Dealer Service Instructions for:

# **Safety Recall T54 / NHTSA 17V-542**

## **Second-Row Seat Belt Buckle**

**2017-2018 (RU) Chrysler Pacifica**

**Figure 2 – Seat Side Covers**

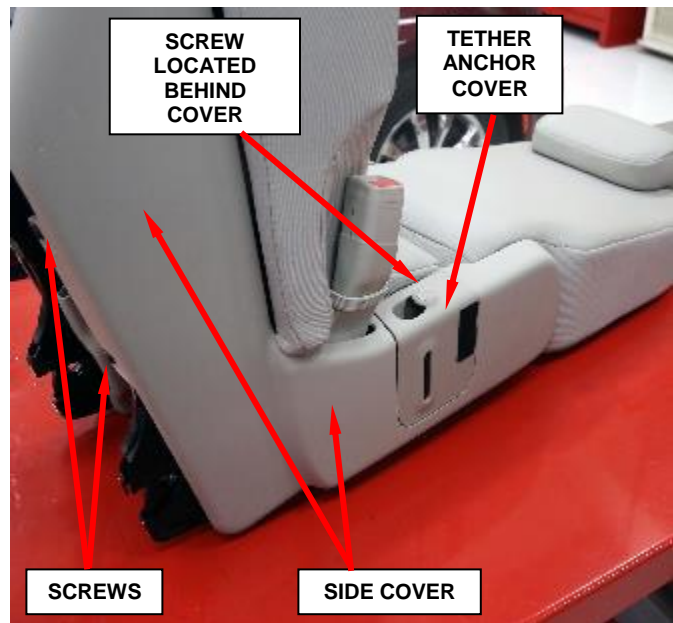
3. By hand, pull to remove the front cover (Figure 1).
4. By hand, pull the tether anchor cover forward and outward to remove (Figure 2).
5. Remove the screw behind the tether anchor cover (Figure 2).
6. Remove the two screws and then remove the side cover (Figure 2).

10. Install the side cover and the two screws. Tighten the screws securely (Figure 2).
11. Install the screw behind the tether anchor cover. Tighten the screw securely.
12. Position the tether anchor cover and push rearward to install (Figure 2).
13. Install the front cover (Figure1).
14. Install the second-row center seat in the vehicle.
15. Return the left outboard second-row seat to the original position.
16. Return the vehicle to the customer.

Figure 3 – Seat Belt Buckle

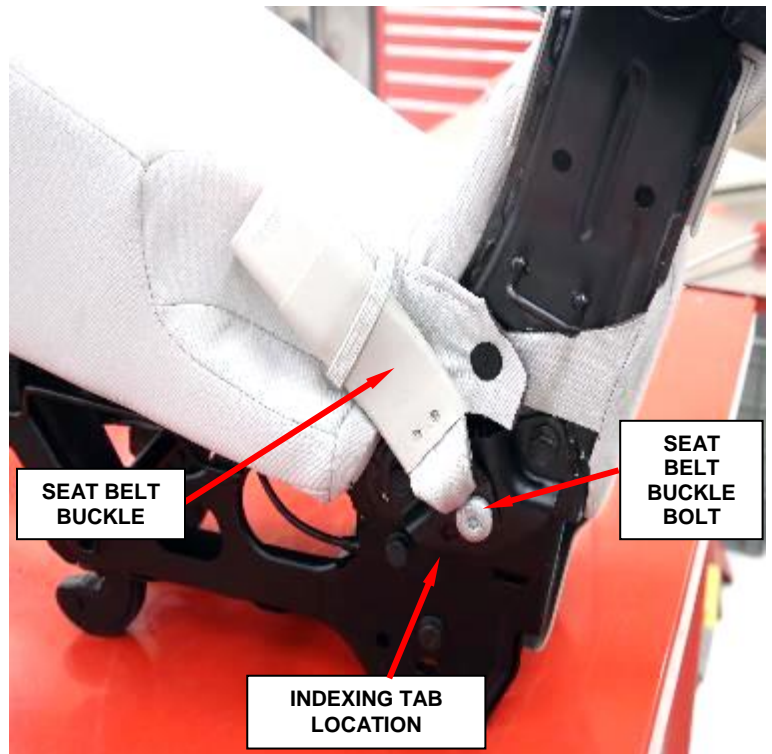
7. Remove and **discard** the seat belt buckle bolt then remove and **discard** the seat belt buckle. (Figure 3).

8. Position the **NEW** second row center seat belt buckle anchor plate onto the side of the seat cushion frame **with the indexing tab in the slot of the seat cushion frame** (Figure 3).

9. Install the **NEW** bolt that secures the buckle anchor plate to the seat. Tighten the bolt to 55 N·m (41 ft. lbs.) (Figure 3).

Figure 4 – Seat Belt Buckle Comparison

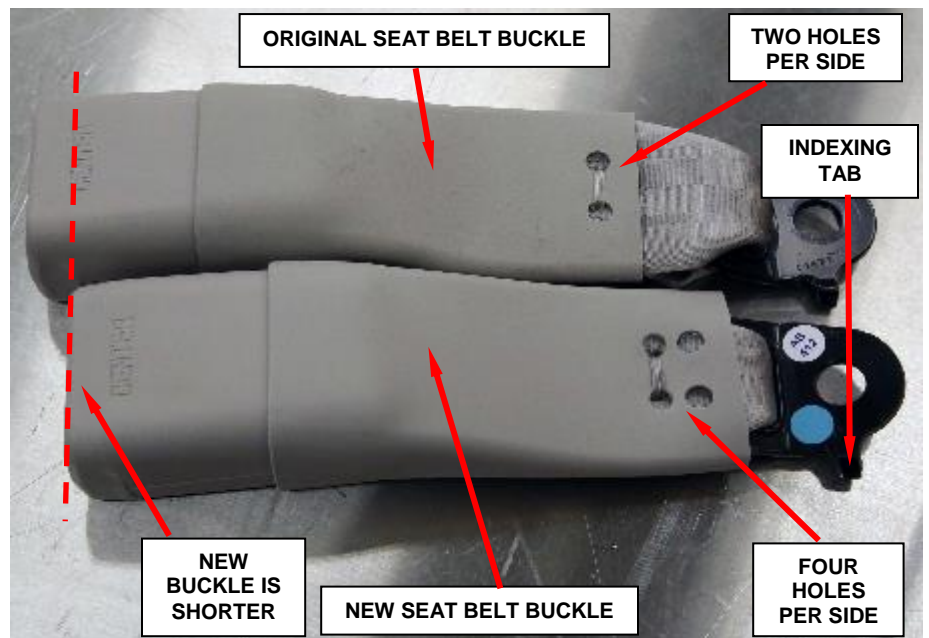
**CAUTION:** The new seat belt buckle is shorter than the original. Be sure to discard the original seat belt buckle (Figure 4).
